SERVICE BULLETIN

REVISION NO. 3, DATED 2004/02/03

Bulletin No. 60-723-28-5
Revision 3, 2004/02/03
H/A 8-272-3
ATA 28-31

**FUEL OVERRIDE/JETTISON PUMP: MODIFICATION OF MOTOR-IMPELLER SUBASSEMBLY
P/N 60-72301 (BPN 60B92603-18) TO P/N 60-72301-3
(BPN 60B92603-318)**

Inlet Impeller-to-Inlet Adaptor Clearance
Figure 1

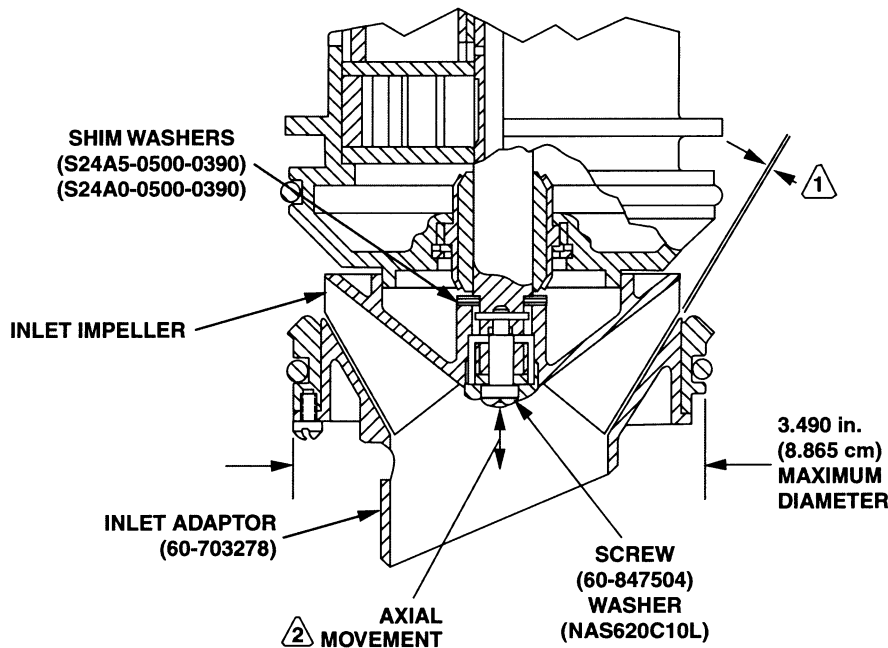
- (F) Measure the clearance between the inlet impeller and inlet adapter by inserting a feeler gauge with a width of 0.200 inch (05.08 cm) or less and a thickness of 0.007–0.010 inch (0.018–0.025 cm) between the two parts.

NOTE: Clearance between the inlet impeller and inlet adapter must be 0.007 to 0.010 inch (0.018–0.025 cm). Add or remove shim washers, S24A5-0500-0390 or S24A0-0500-0390, to get the required clearance. The ratio of clearance to washers is 1:2. That is, a 0.001-inch difference in clearance requires a 0.002-inch change in shim washers.

1 0.007 – 0.010 in (0.018 – 0.025 cm) CLEARANCE.

2 0.001 – 0.008 in (0.003 – 0.020 cm) AXIAL MOVEMENT BEFORE AND AFTER TEST.
